MILITARY DEPARTMENT
STATE of NEBRASKA
LINCOLN, NEBRASKA
NEBRASKA ARMY NATIONAL GUARD
CATS NE Ave – Boulevard Construction
at the
Camp Ashland Training Site
220 County Rd A
Ashland, NE

PROJECT NO. 31090433

A D D E N D U M N O . 2

2 TYPICAL SECTION
NEBRASKA AVENUE (STA. 13+09.78 - STA. 24+74.65)
NO SCALE

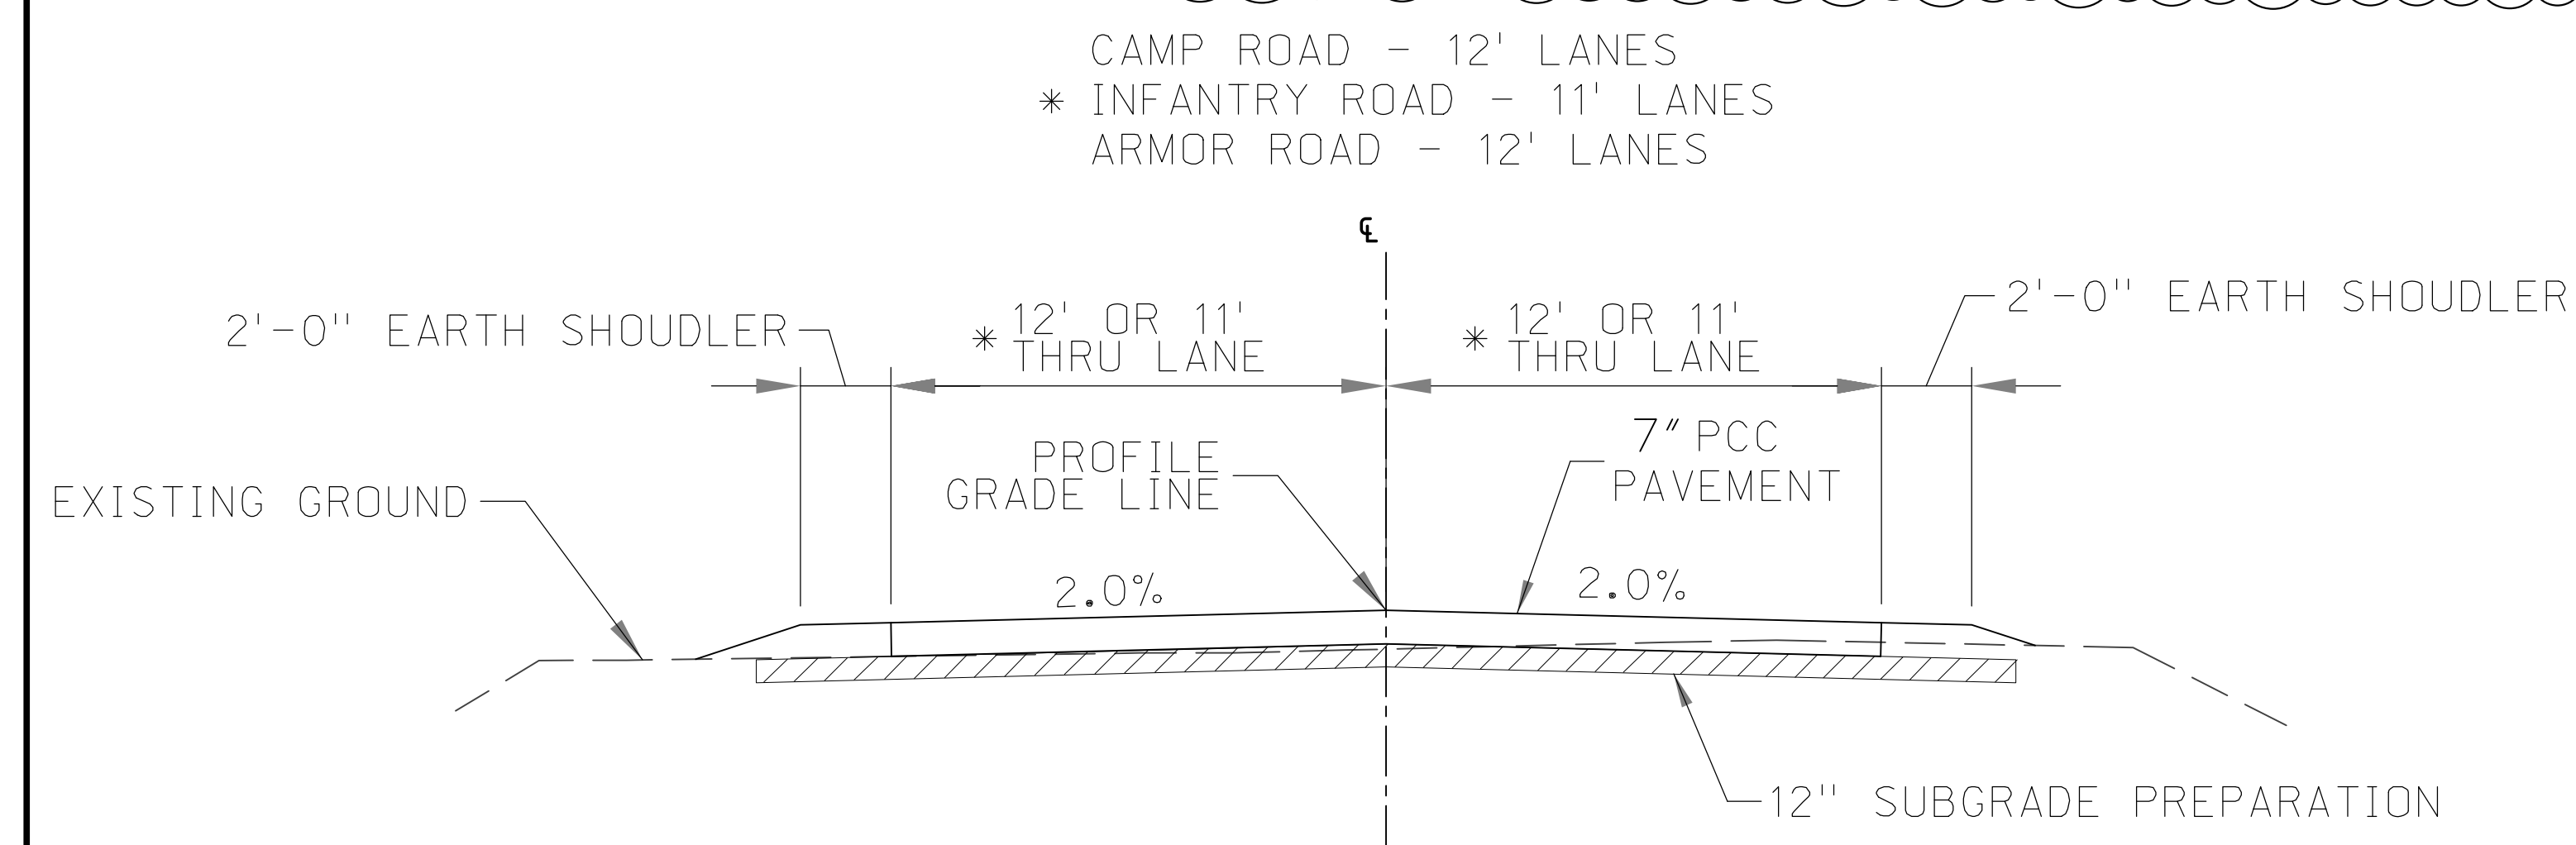
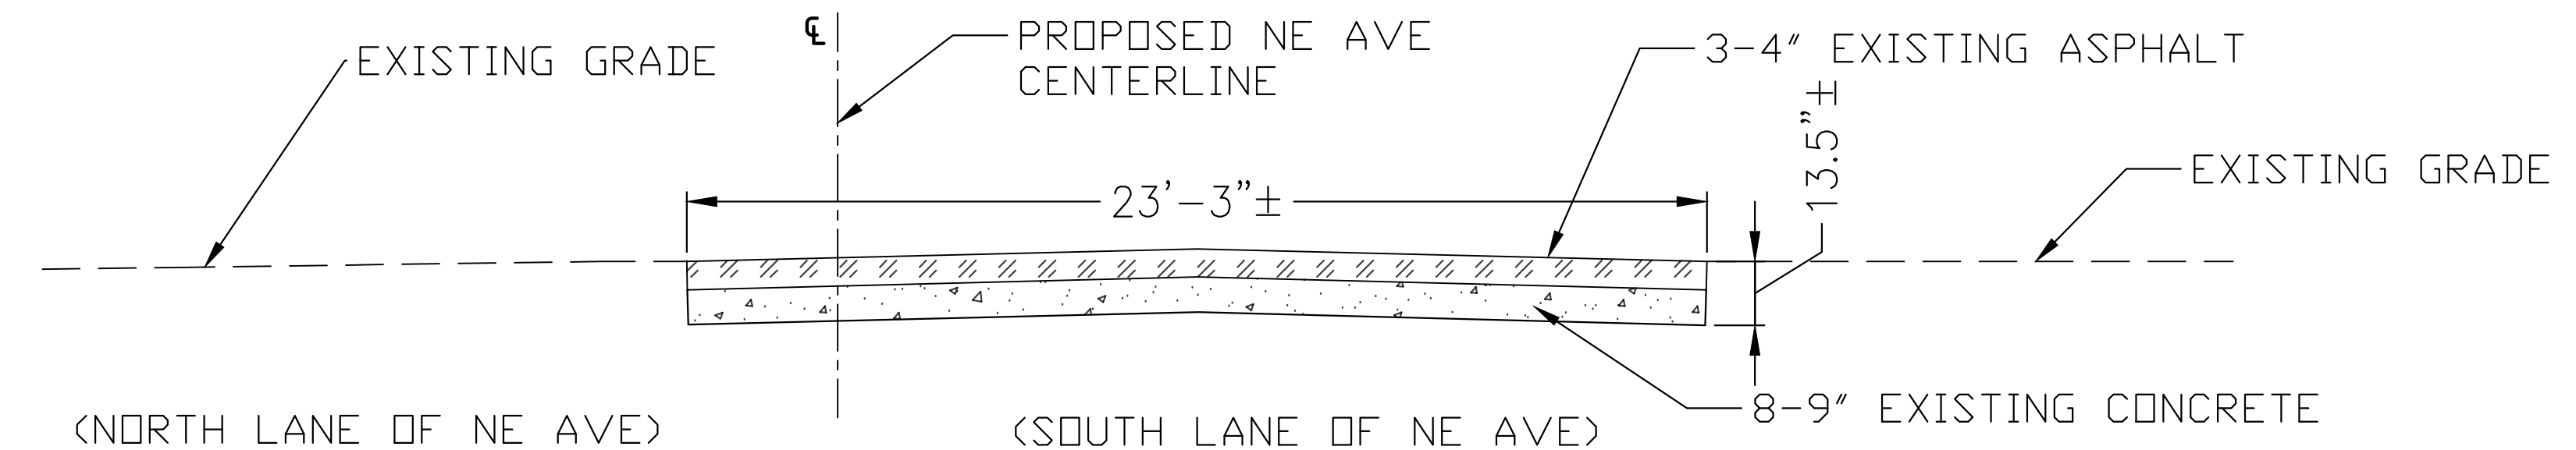
- ADD 2-9: Sheet C301, Detail 2 revise notes as follows:
- Upper left note, “...7” PCC PAVEMENT, ..., remove, THICKNESS MAY BE GREATER THAN 7”, FIELD ADJUST.”

- Under detail 2 label, change to read, “NEBRASKA AVENUE (STA 13+09.78 – STA 24+74.65)
 - Change “3-4” milled asphalt...” to read “4” milled asphalt as base course, excess millings to be stockpiled in the salvage area south of the maintenance building.”

- Change under island note, “10-12” of 47B-3500psi concrete island surfacing” to read, “5” of 47B-3500PSI CONCRETE ISLAND SURFACEING OVER 6” OF CRUSHED ROCK”.

C301

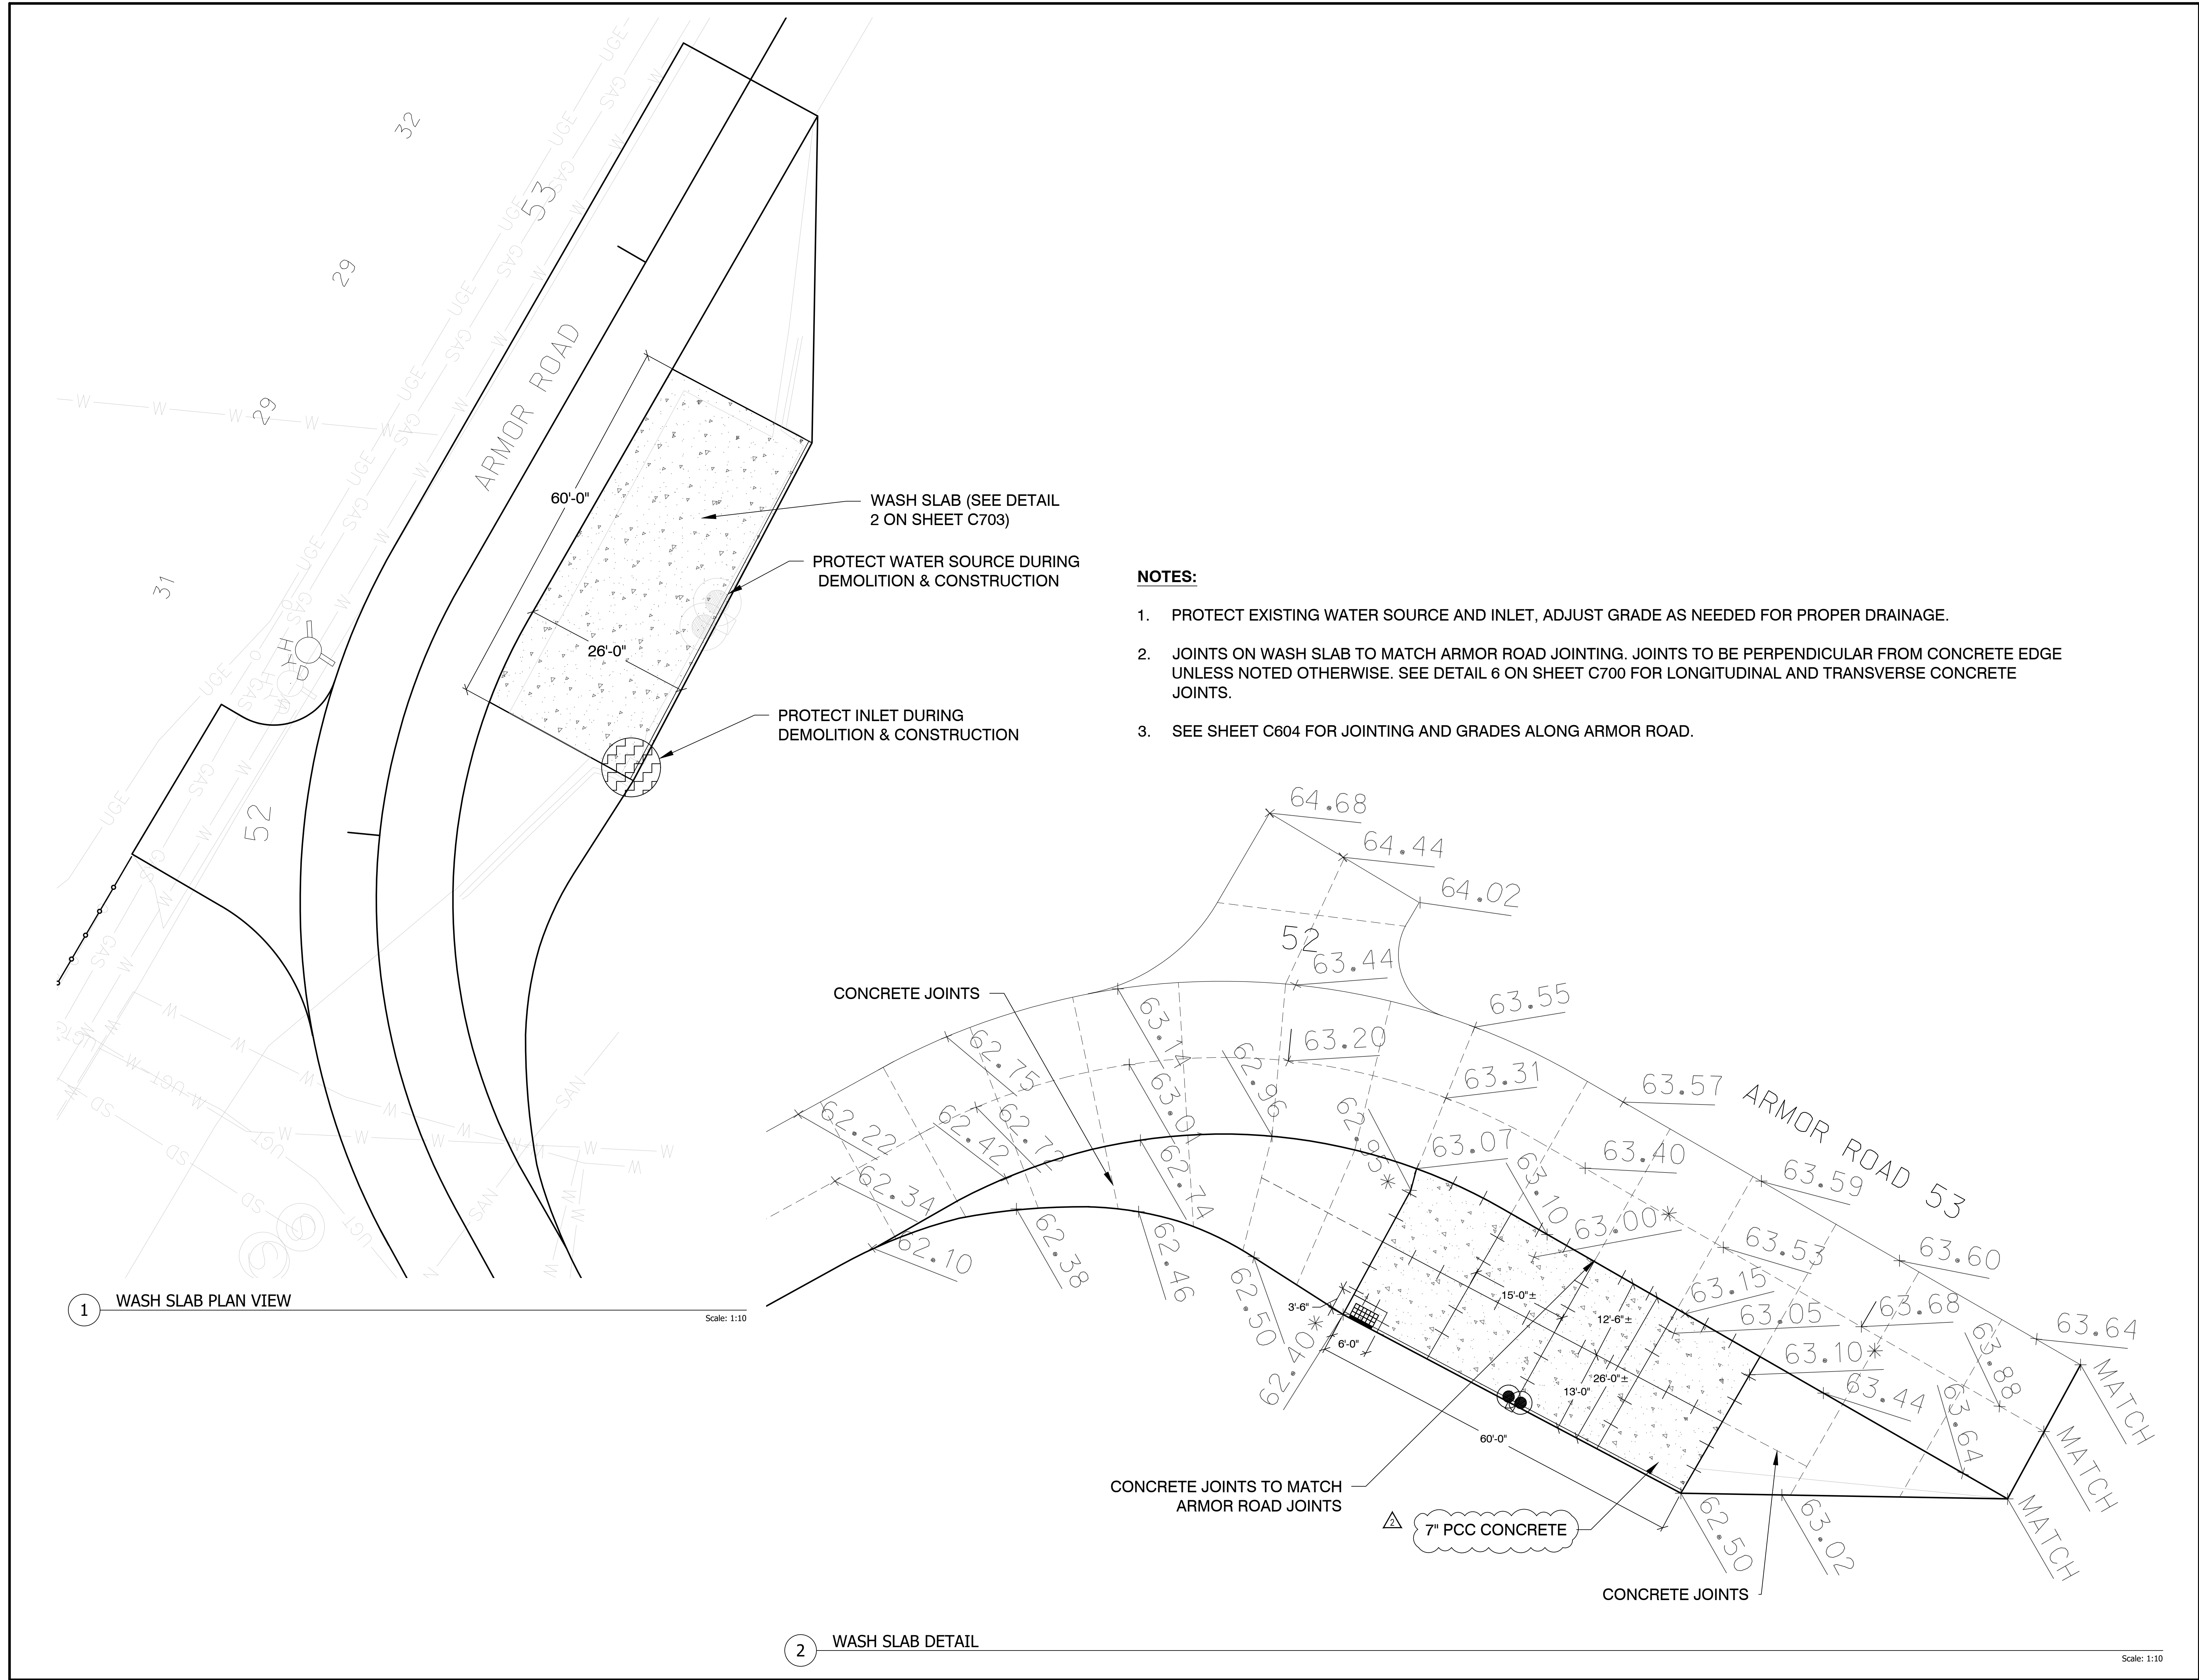
- Detail 4, Construction Notes, Notes have been revised.
